**Re: Preliminary Site Plan Review Application; Conversion to Residential
Tax Map 1, Lot 32, 35 Badgers Island West
Response to CMA Comments**

On behalf of BIW Inc. we hereby submitted revised plans and supporting material for **Preliminary Site Plan Review Approval** to address the comments from the May 18, 2023, review letter from CMA Engineers. The review was of our April 6, 2023, submission. The Planning Board, at your April 27, 2023, meeting, voted to schedule a Public Hearing for the May 25, 2023, Planning Board. The comments were just received on May 18th. While we understand there is limited time to review our response prior to the meeting, we would like the opportunity to walk the Board through our response at the meeting. The specific comments, repeated below with our responses in bold text, are as follows:

UTILITY PLAN **C3**

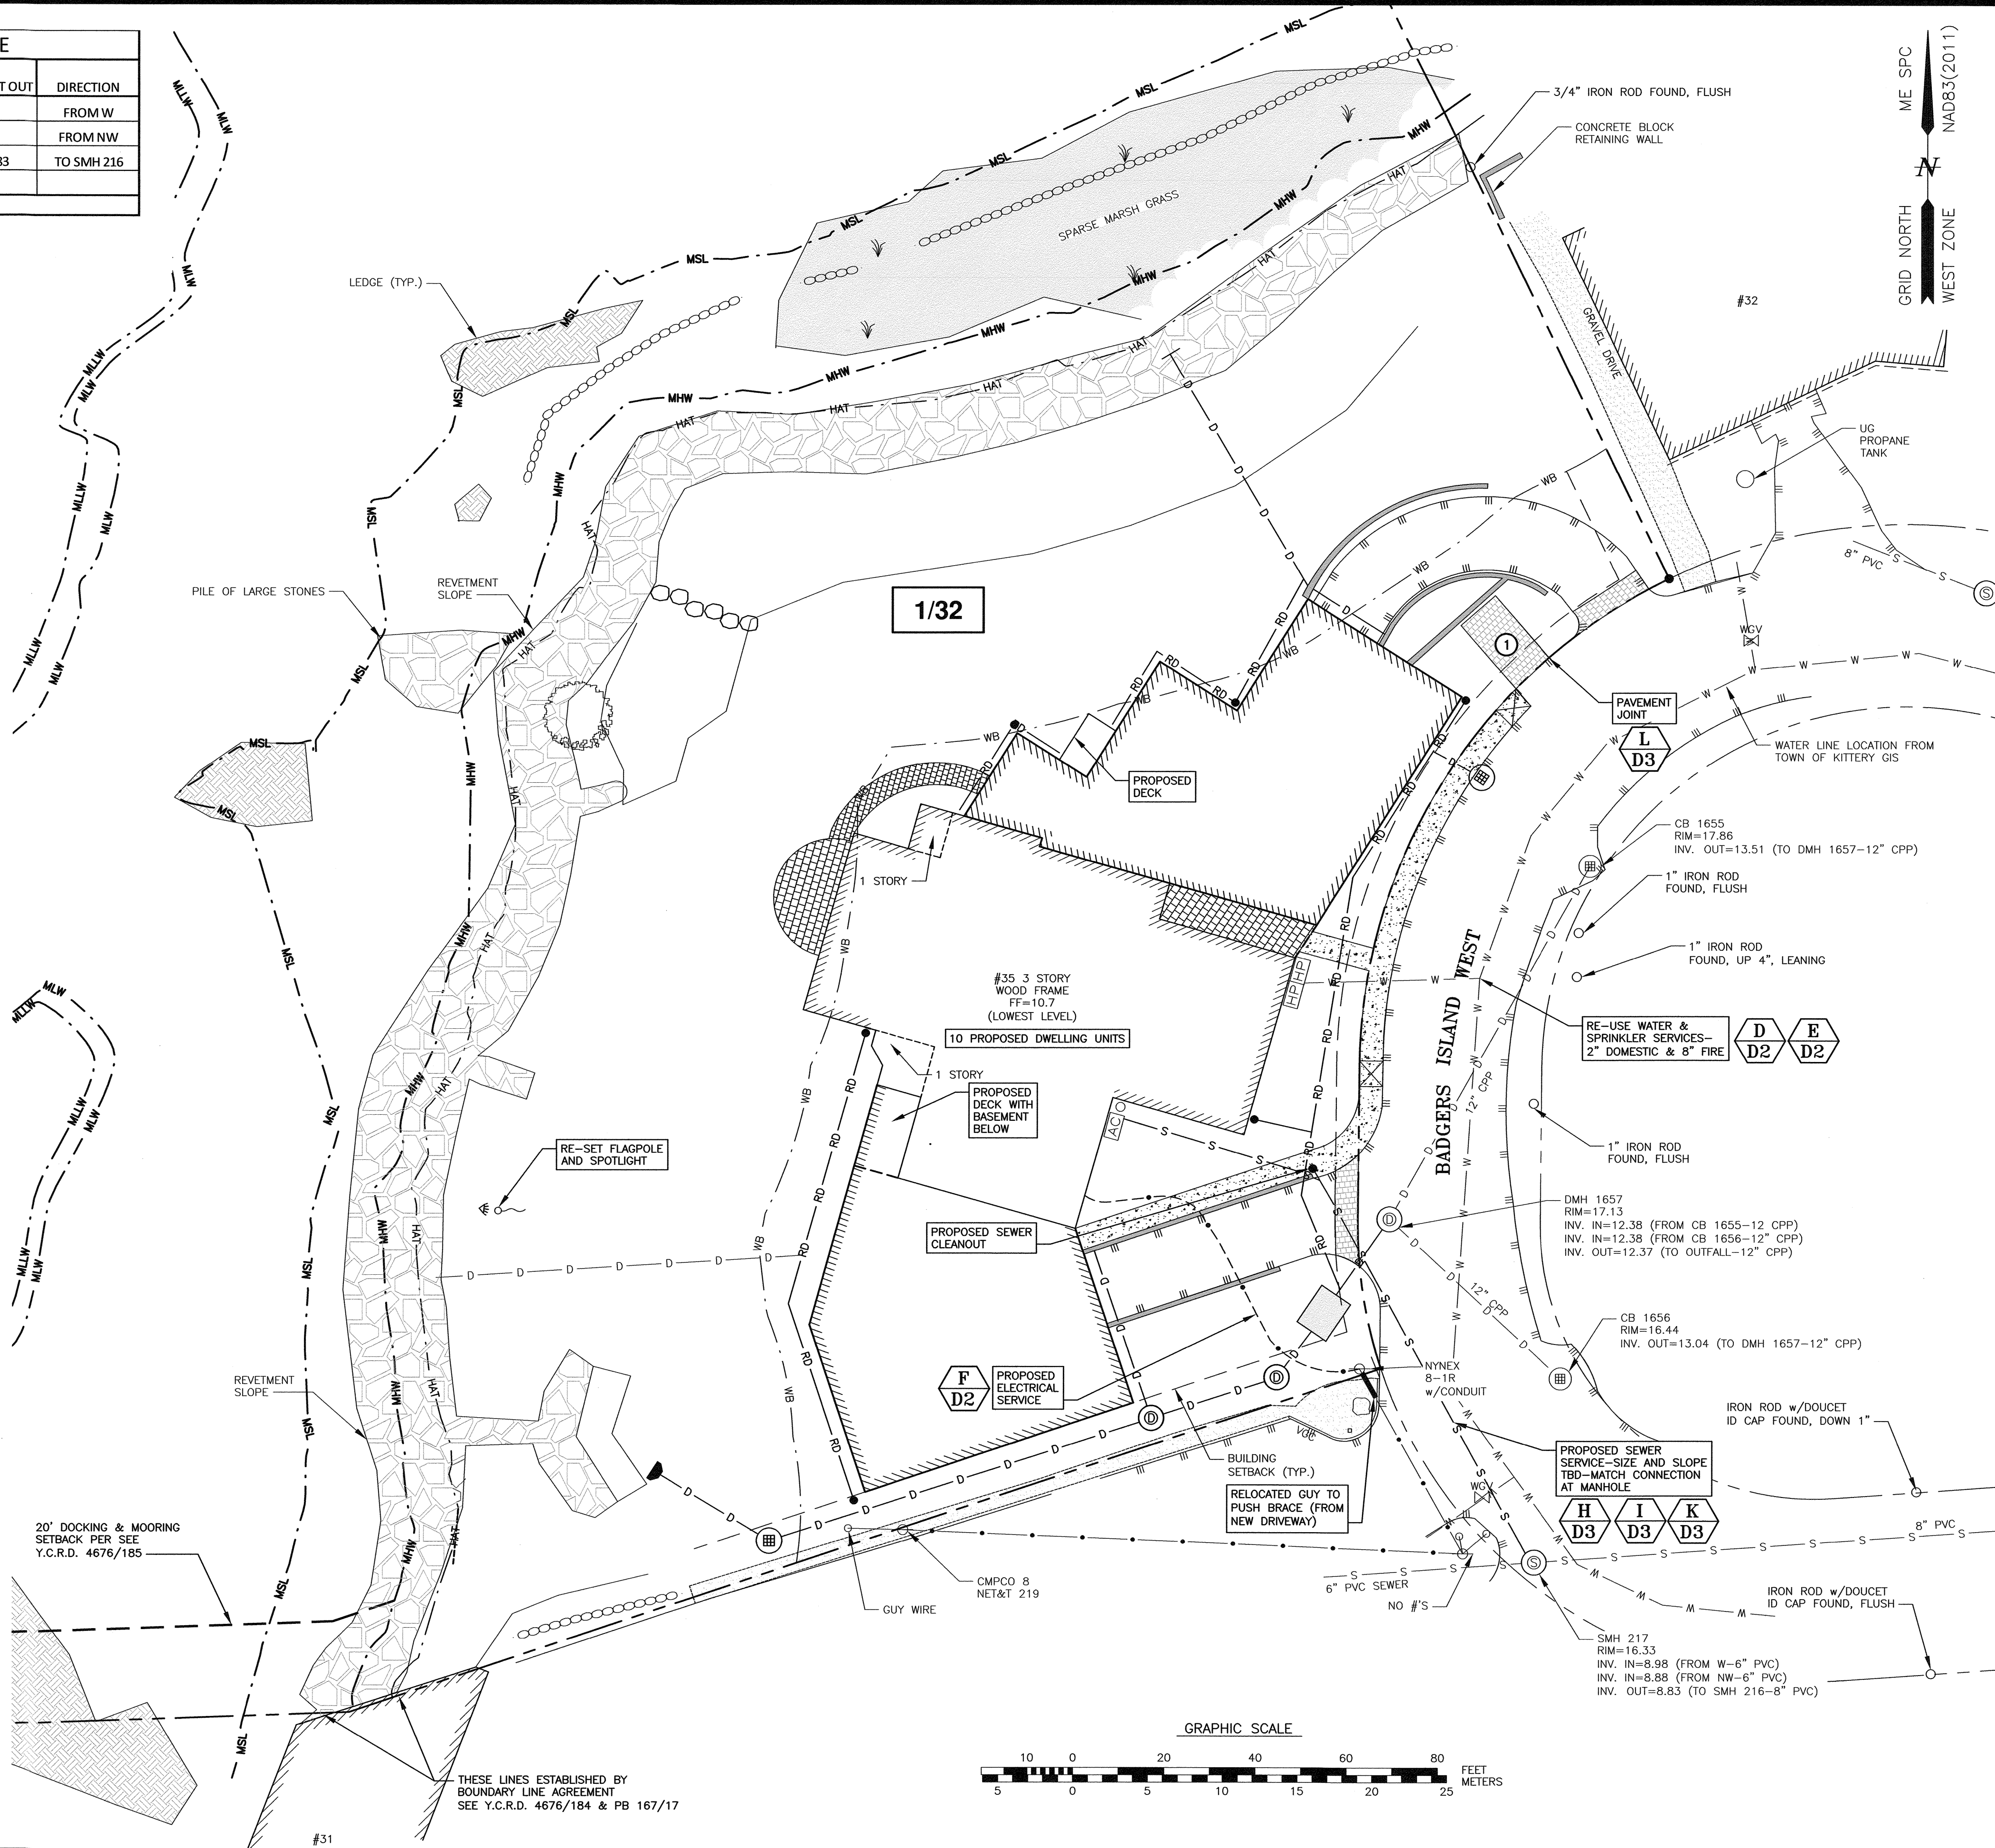
1. The leader “Sewer Line to be Relocated” is confusing because it shows the existing and proposed sewer with leaders to both without a clear difference in the line types. Call out the new service separately (with the pipe size, material, and slope). **Done.** Is the invert out of the manhole the same? **Yes.** There should be details, notes, etc. on abandoning the old penetration, reconfiguring the manhole invert trough, if necessary, etc. **Notes have been added to the plans in this regard.**

2. Callout the new underground service run. **Done.**
3. The leader “Re-Use Water and Sprinkler Services” points to one water service. What is the size? **Noted on plan.** Is there capacity for domestic use and fire suppression in this one service? **There are 2 services, we will work with the water department to confirm adequacy. There will be a net deduction in fixtures with the building conversion, including the addition.**

4. The location of the sewer cleanout should be shown on the plans. **Added to the plan.**
